WARRANTY INFORMATION SERVICE INFORMATION

Propshaft Upgrade for Mercury Racing 2001 Model Year Gear Cases

Propshafts are for illustration only and do not represent any particular model.

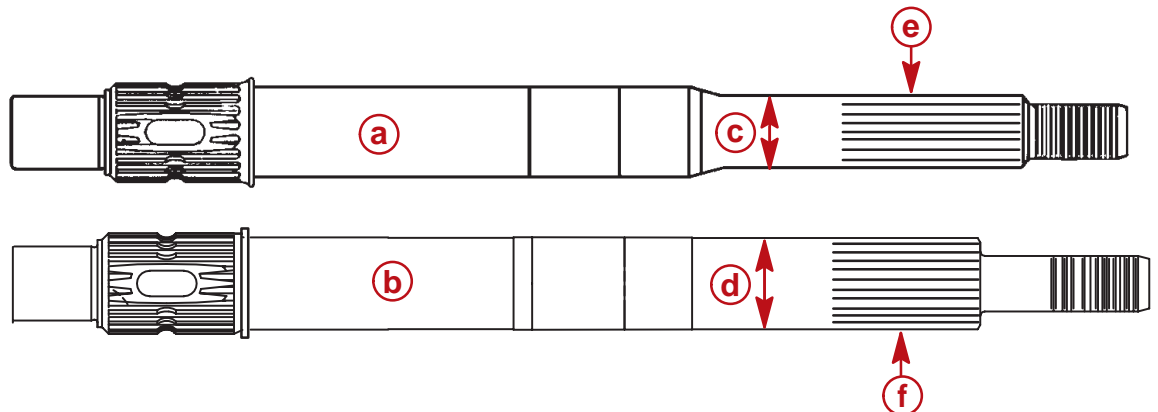
The diameter of the spline area for the propeller has been increased and the number of splines has changed from 15 to 19 spline. These new propshafts give greater durability in surface type applications. **The heavy duty propshaft requires use of propellers with replaceable hubs.**

- a** - Standard Mercury Racing Propshaft Prior to 2001 Model Year
- b** - Heavy Duty Mercury Racing Propshaft Starting With Model Year 2001
- c** - Diameter of 1 in (25 mm)
- d** - Diameter of 1.25 in. (32 mm)
- e** - 15 Splines
- f** - 19 Splines

Hub kit part number for heavy duty propshaft: 840389A2
